Purchasing Department  
530 Water Street  
Oakland, CA 94607

### ADDENDUM No. 1

#### RFP No.: 21-22/32 – T1 Holdroom Seating Replacement

Gate 5 & 7	Notes
Seating Capacity: 188	Gate 5 & 7 have an estimated shared holdroom space of 2163 sq. ft (103'x21'). Vending machines occupy a portion of the wall as well as entry/exits to a Women's Restroom.

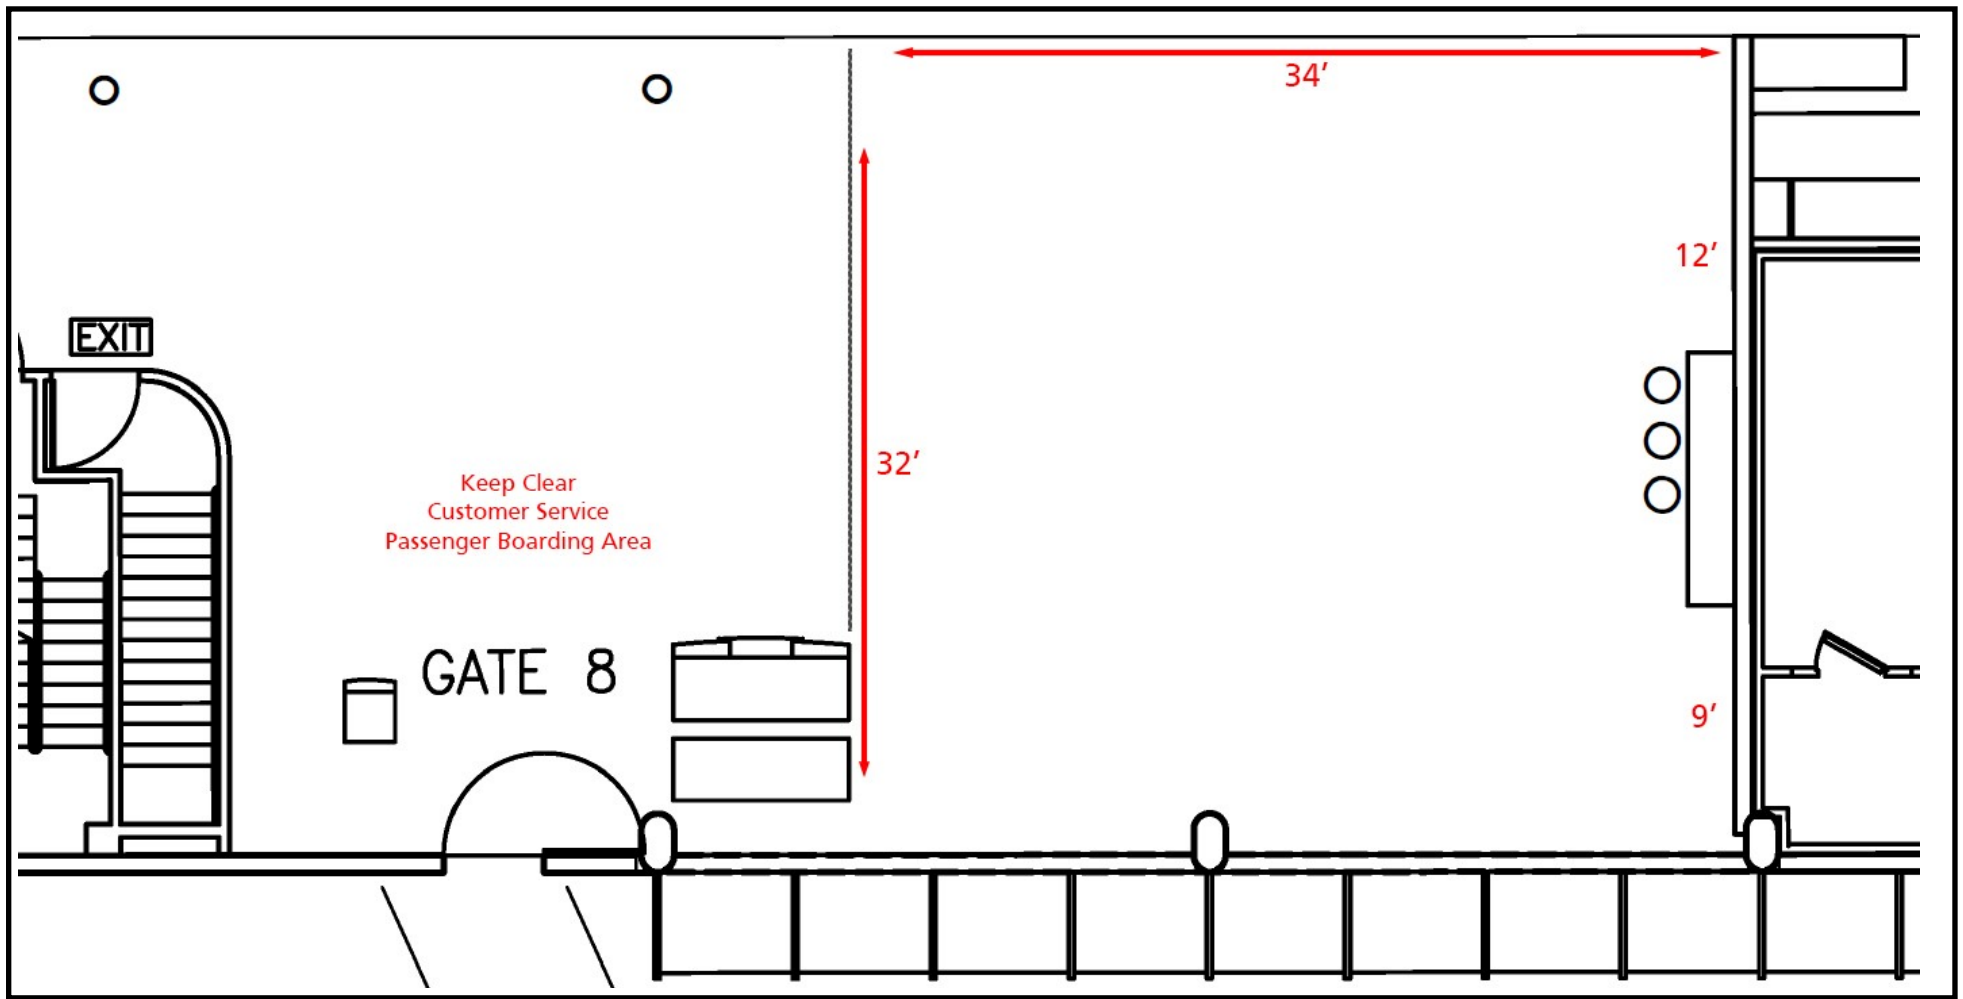
- *Gates 5 & 7 maps were accidentally left off the original RFP diagrams and are included in this addendum. (Please also see question 19 below.)*
- *No seats are needed for Gates 3, 4, & 6.*
- *The diagrams included in the RFP were from an old drawing so currently there are no Gate 3A, 7A, or 8B.*

*Answer: Yes, the above gates are correct. Gates 5 & 7 maps were accidentally left off the original RFP diagrams and are included in this addendum.*
